FIGURE 2209.5.3
INDOOR ATTENDED FAST-FILL HYDROGEN FUEL-DISPENSING LIMITATIONS.

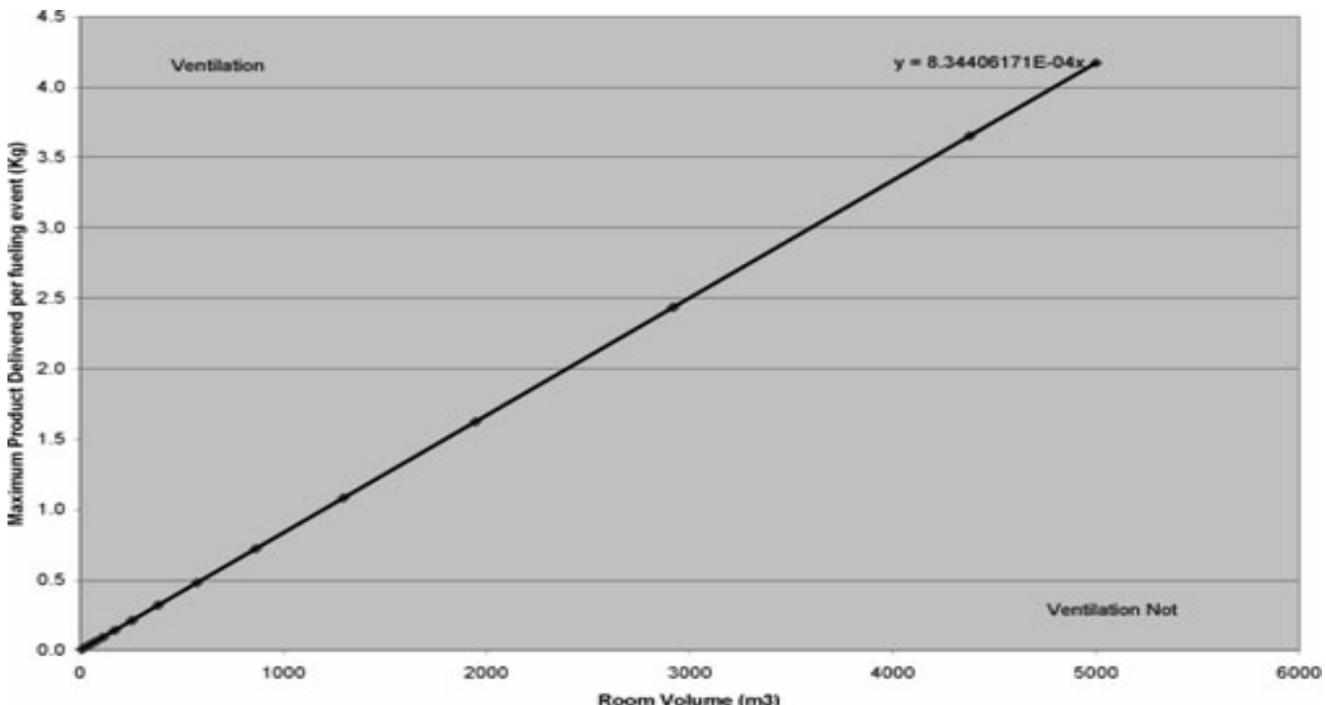
Exception: Indoor attended fast-fill hydrogen fuel-dispensing areas not exceeding the space volume and maximum fuel delivery mass per refueling event as depicted in Figure 2209.5.3.
